MAGNOLIA SPRINGS SUBDIVISION, PHASE II

Revised for the July 8th meeting:

APPLICATION NUMBER 5 DATE July 8, 2010

DETAIL SITE PLAN

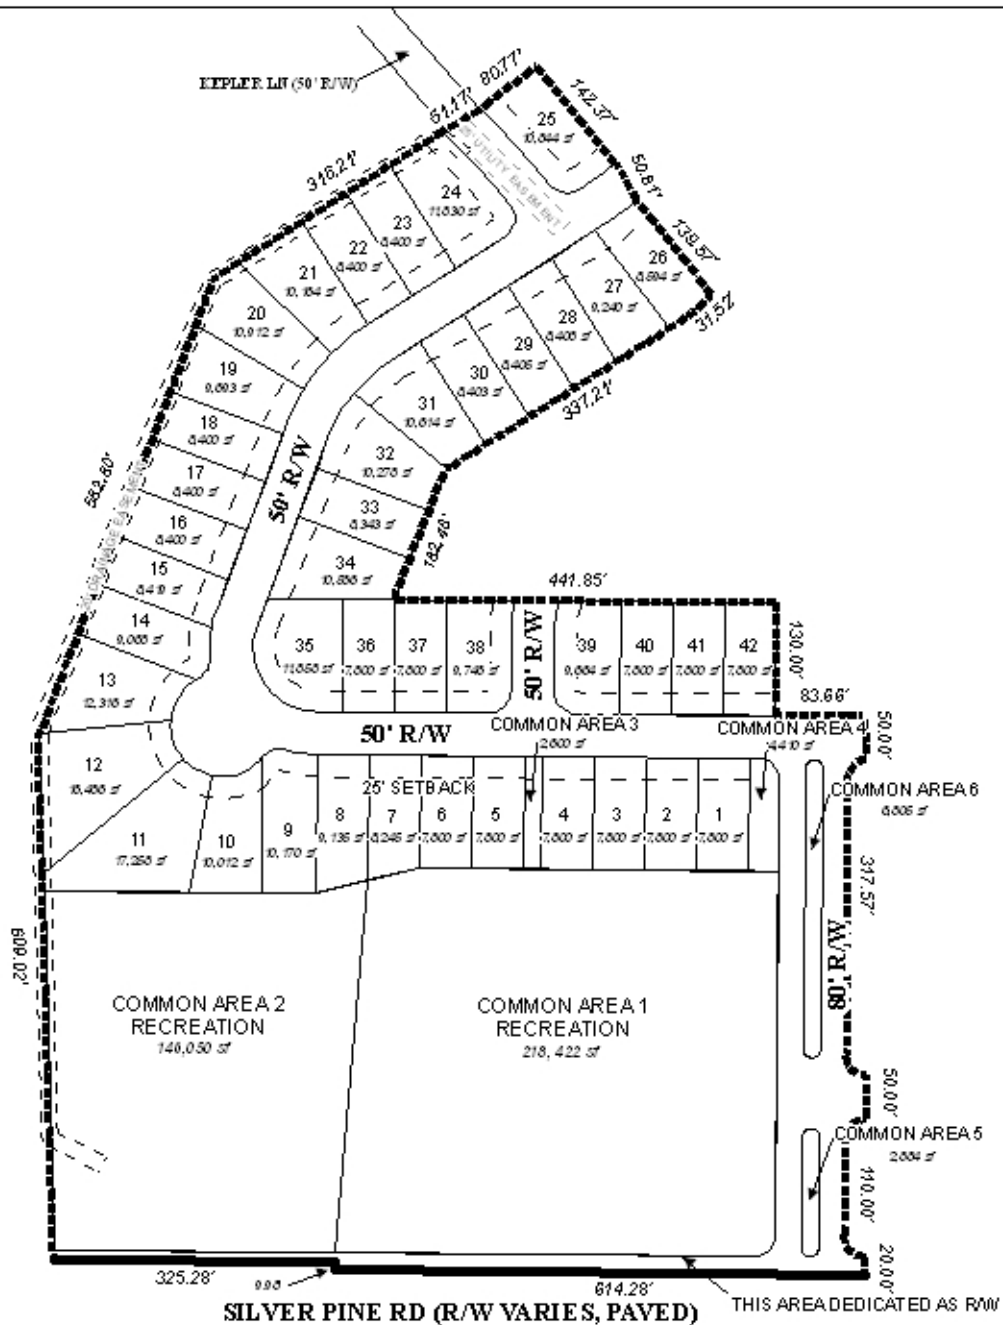
The plat illustrates the proposed 22.5± acre, 42-lot subdivision, which is located on the North side of Silver Pine Road at the North terminus of Maple Valley Road. The applicant states that the subdivision is served by public water and sanitary sewer.

There are several issues of concern with the proposed subdivision; first of all, a condition of approval for the overall 440 ± acre, 948 lot subdivision from the April 19, 2007 meeting of the Planning Commission was that each individual phase be submitted to the Planning Commission for review; however, this subdivision application expired in April of 2008. It should be noted that Phase One was approved as a separate application on November 21, 2008 and recorded in January of 2009: the approval of Phase One included a requirement for a Traffic Impact Study for the entire development with any future phase. It should be noted that the applicant did not submit a Traffic Impact Study with this phase of development; thus the study should be submitted with the new overall subdivision application. Secondly, all previous approvals have expired and no extensions have been filed; thus a new application for the overall development will need to be submitted. Thirdly, the proposed Phase Two seems to be deviating from the overall subdivision plan. Finally, the applicant has failed to comply with previous Planning Commission approvals.

- 1) composite subdivision application has expired, submission of a new overall subdivision application is required;
- 2) failure to comply with previous Planning Commission approval condition regarding the submission of a Traffic Impact Study; and
- 3) proposed Phase Two is deviating from the overall subdivision plan.
